Tallaght / Clondalkin to City Centre Core Bus Corridor Scheme

NTA Observations on the Proposed Scheme Submissions

September 2023

Figure 2.1.10: Extract from Proposed Surface Water Drainage Works Drawings from Figures: Part 2 of 3 of Volume 3 of the EIAR (Sheet 6)

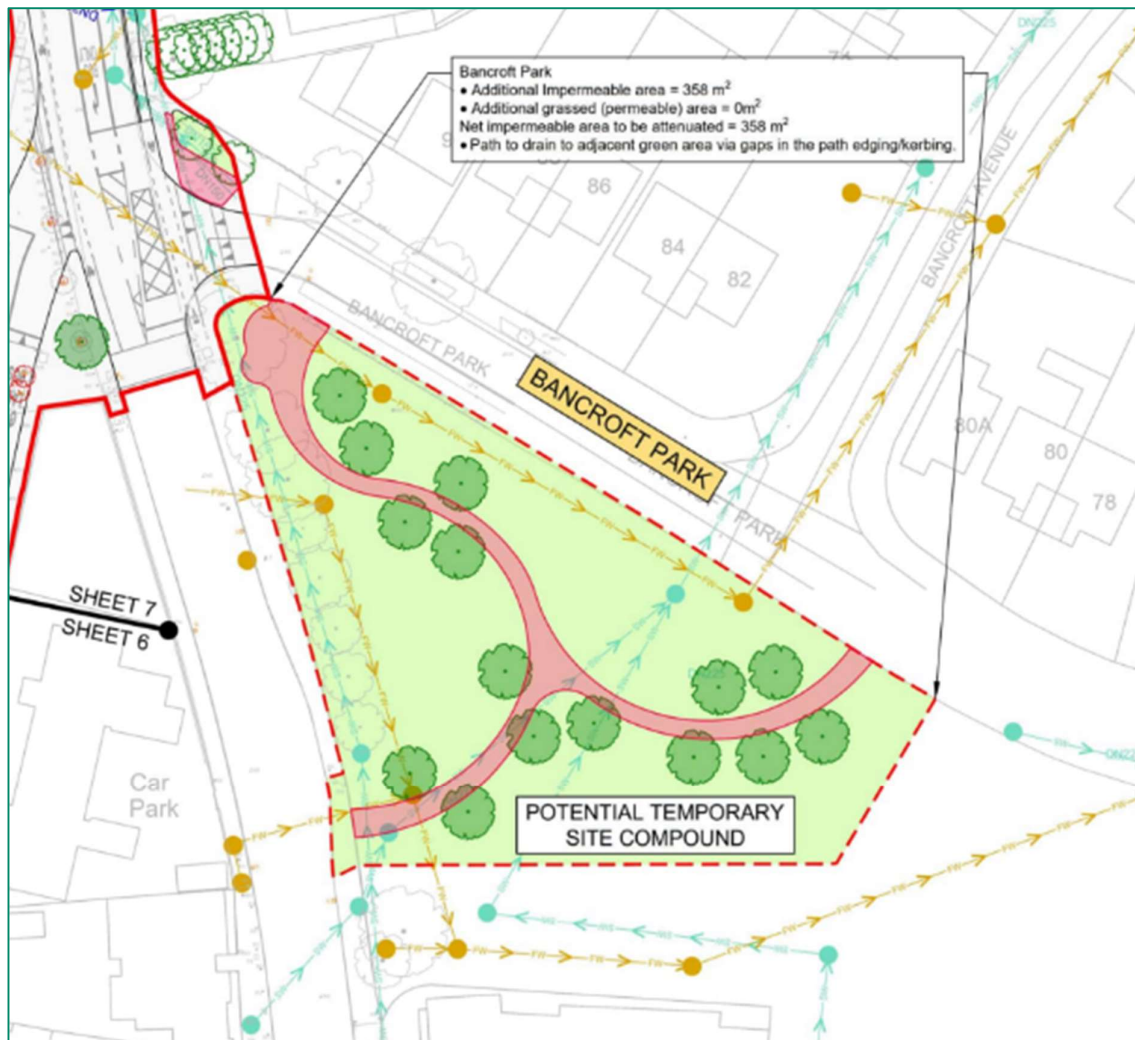
Figure 2.1.10 is an extract from Proposed Surface Water Drainage Works Drawings from Figures: Part 1 of 3 of Volume 3 of the EIAR and shows the additional impermeable area for the proposed path through the green area at Bancroft Park that will be in place once the temporary construction compound is removed.

Figure 2.2.3: Extract from Tree Clearance Plan Drawings from Appendix A17.1 of Chapter 17 of Volume 4 Part 4 of 4 of the EIA

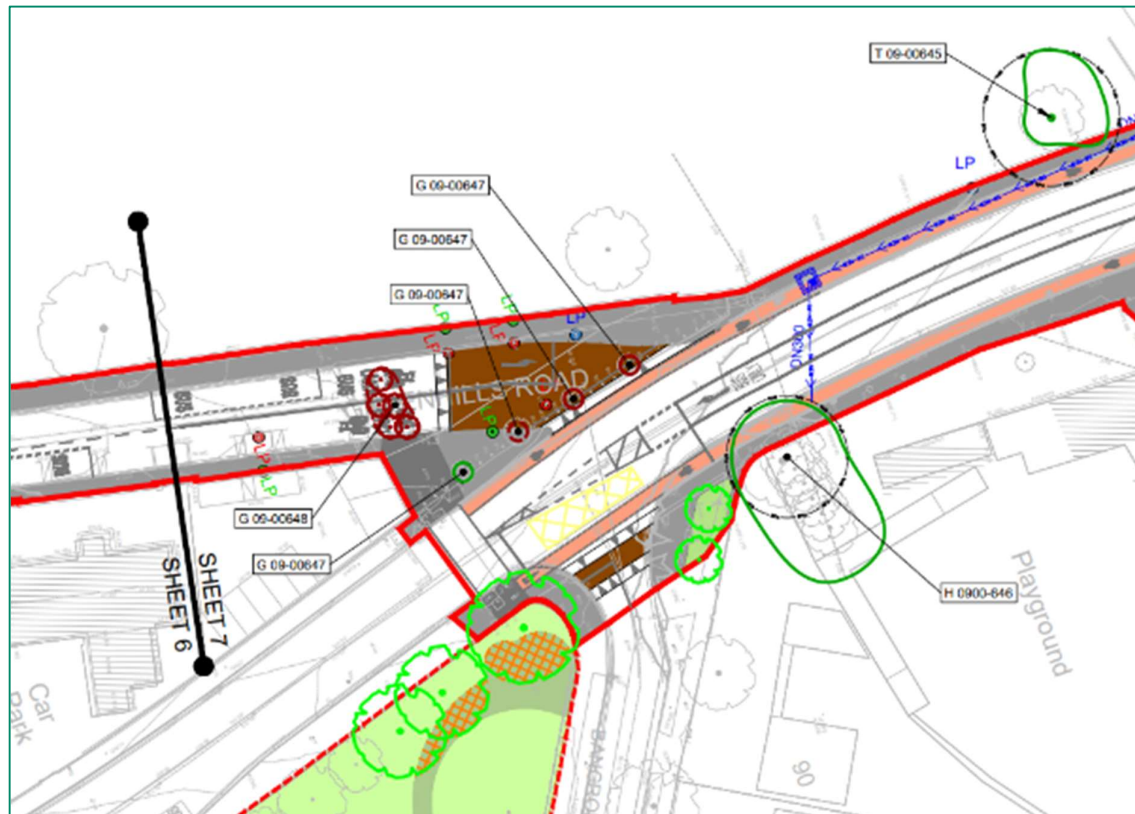
Extract from Tree Clearance Plan Drawings at Old Greenhills Road / Bancroft Park junction which are provided as an appendix to Chapter 17 Landscape (Townscape) & Visual in Part 4 of 4 of Volume 4 of the EIA is included in Figure 2.2.3.

Figure 2.3.5: Extract from SDCC Part 8 Display Drawings Greenhills Road Realignment at Parkview (Section A)

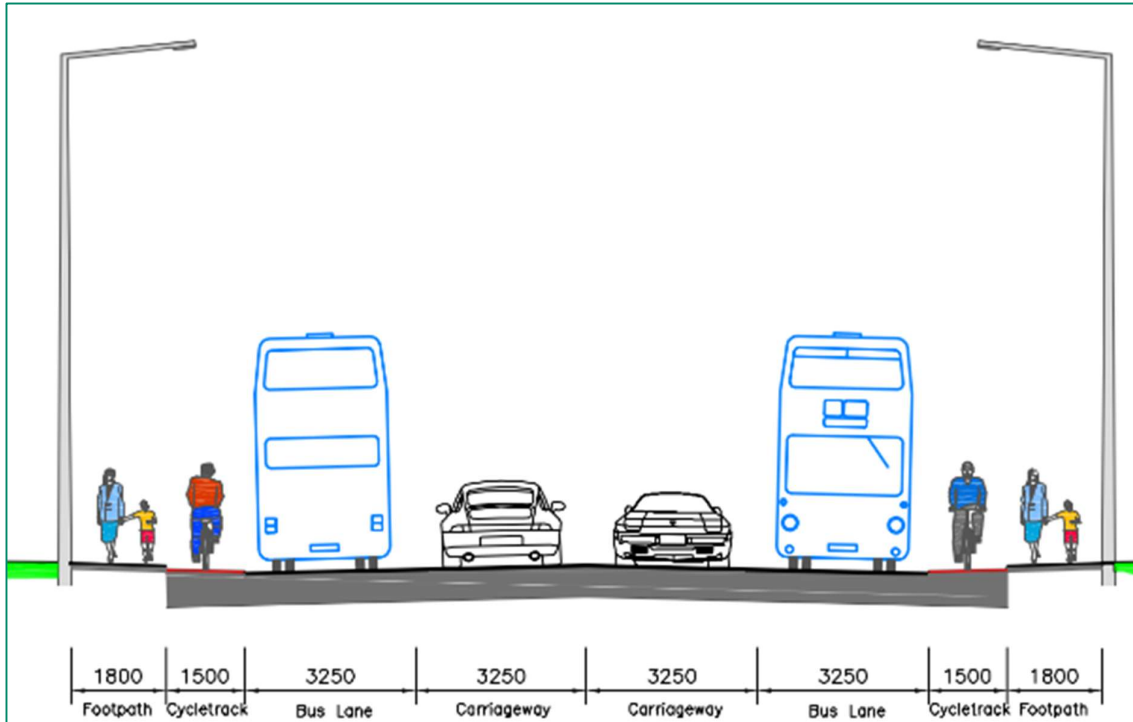
The approved SDCC Part 8 scheme at Parkview consists of a two-way 13.0m wide carriageway, catering for general traffic and bus lanes in both directions and a 3.2m wide cycletrack/footpath on either side of the carriageway as shown in extract from SDCC Part 8 Display Drawings Figure 2.3.5.

Figure 2.3.8: Extract from the EIAR Section 6.4.6.2.9.3 Diagram 6.40: Flow Difference on Road Links (Do Minimum vs. Do Something), AM Peak Hour, 2028 Opening Year

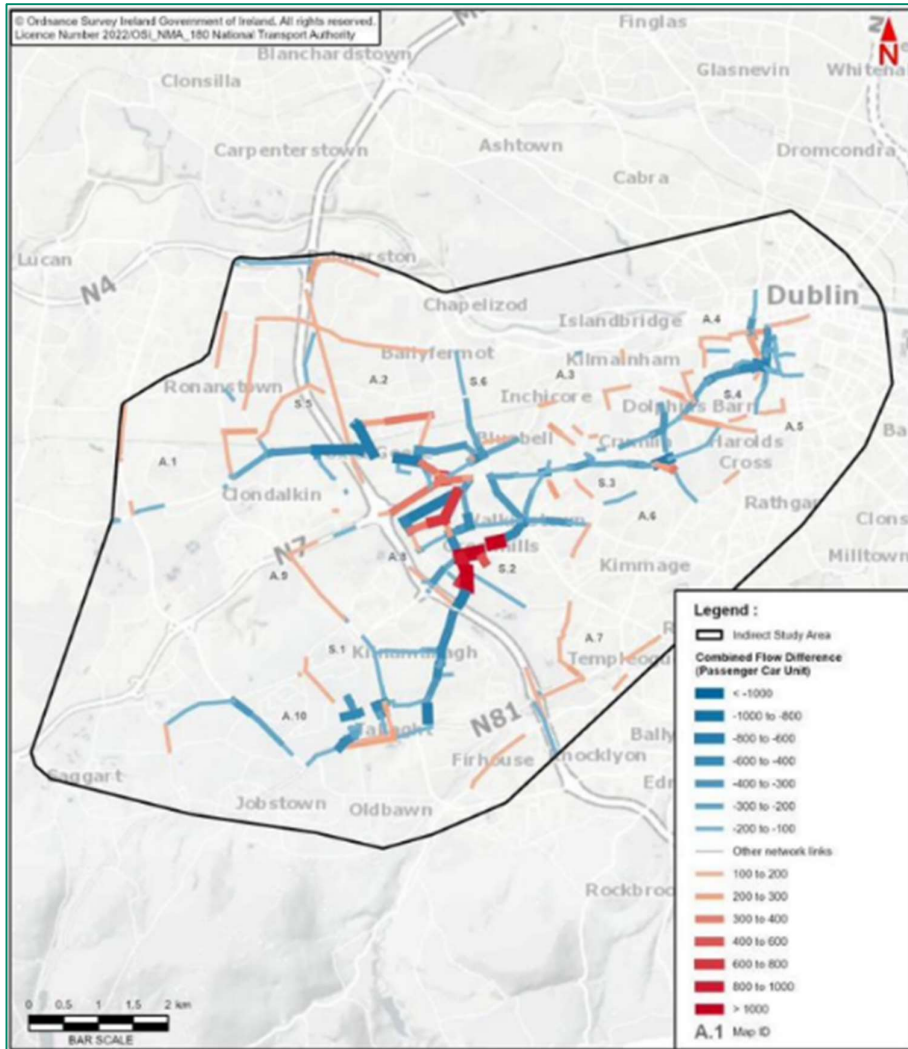
Extract from Section 6.4.6.2.9.3 Diagram 6.40 of Chapter 6 Traffic & Transport of Volume 2 of the EIAR which illustrates the predicted difference in traffic flows on the road links in the AM Peak Hour for the 2028 Opening Year is shown in Figure 2.3.8.

Figure 2.3.9: Extract from the EIAR Section 6.4.6.2.9.3 Diagram 6.41: Flow Difference on Road Links (Do Minimum vs. Do Something), PM Peak Hour, 2028 Opening Year

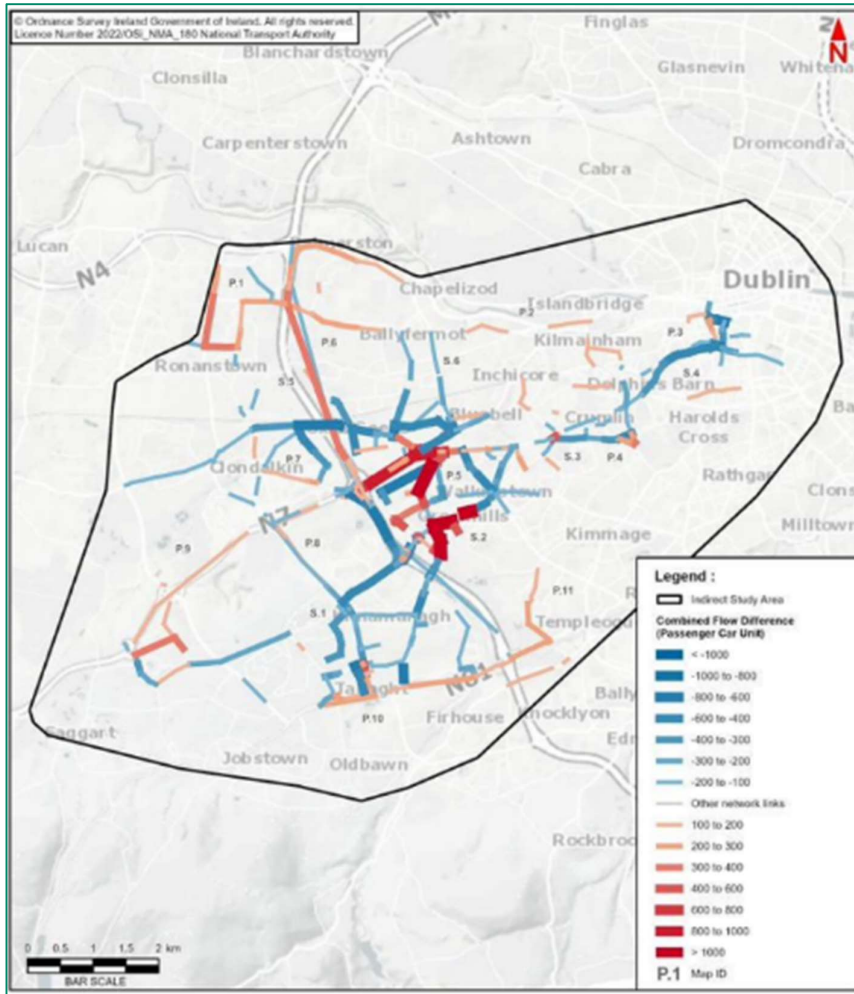
Extract from Section 6.4.6.2.9.4 Diagram 6.41 of Chapter 6 Traffic & Transport of Volume 2 of the EIAR which illustrates the predicted difference in traffic flows on the road links in the PM Peak Hour for the 2028 Opening Year is shown in Figure 2.3.9.

Figure 2.4.19: Extract from General Arrangement Drawing (Sheet 11)

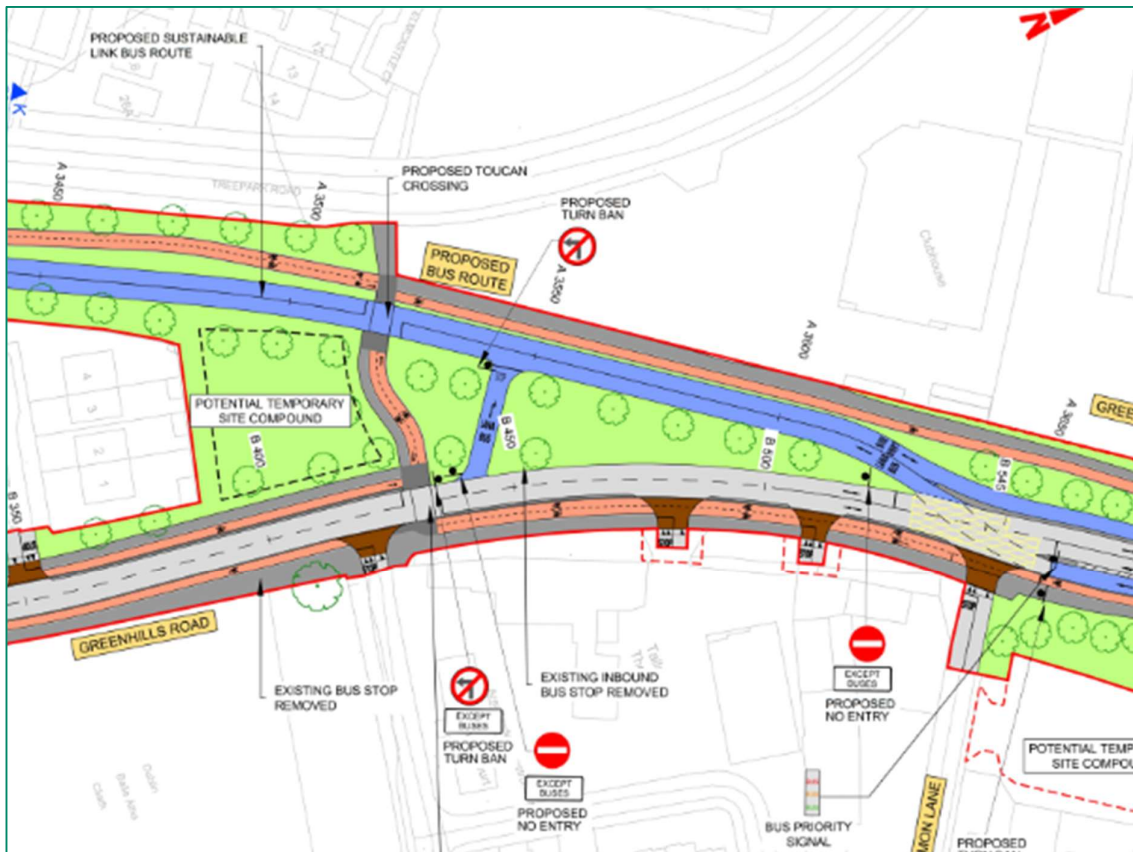
Figure 2.4.19 below is an extract from General Arrangement Drawings from Figures: Part 1 of 3 of Volume 3 of the EIAR showing proposed inbound priority bus link between Greenhills Road and new bus route adjacent to Treepark Road and the bus priority signal at Tymon lane junction.
